| Subject: AUXILIARY PORT VALVE (APV) REMOVAL CAUTION | Bulletin No: 01-034/11 |

2004-2008 Mazda RX-8 with High Power

2009-2011 Mazda RX-8

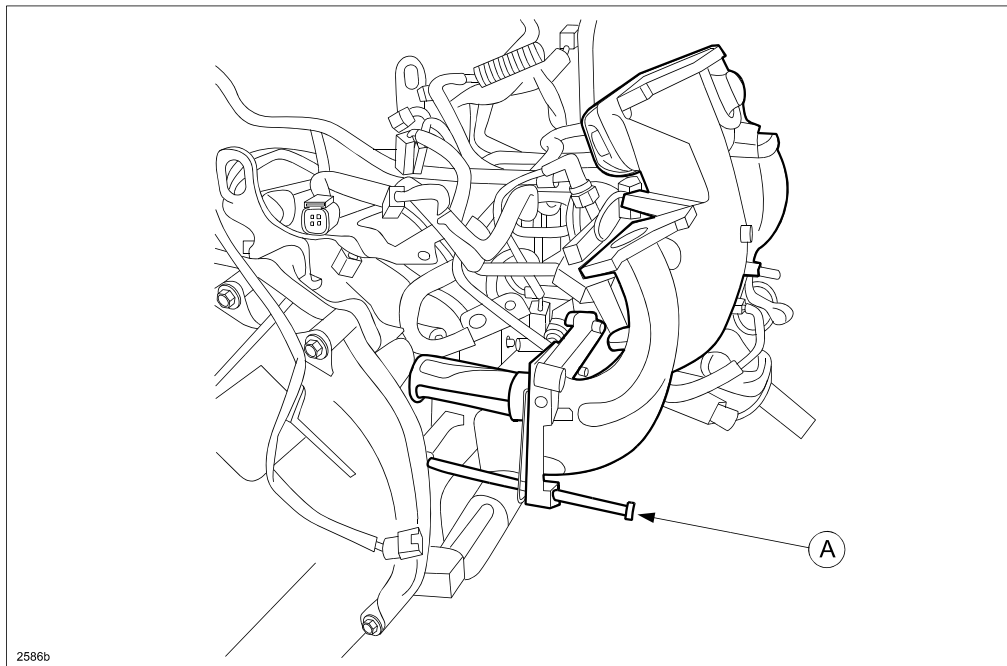
NOTE: When removing the inlet manifold, use two long bolts (A) [M8 - 1.25x220 hex bolt] in both the lower outer bolt holes to help support the manifold and slide out the APVs. This will take pressure off the APV arms so they will have less chance of breaking.

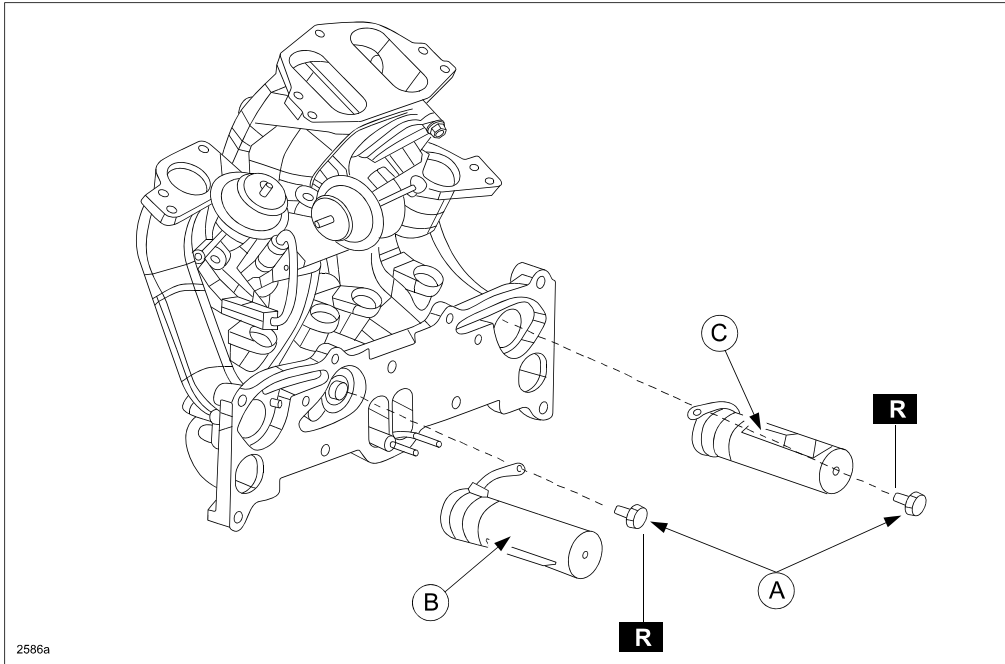
- If the APV is damaged during removal, remove the APV bolts (A), then remove the front APV (B) and/or the rear APV (C) from the inlet manifold and replace with a new one.

APV bolt tightening torque: 0.9-1.2 Nm (9.2-12.0 kgf-cm, 8-10 in-lbf)
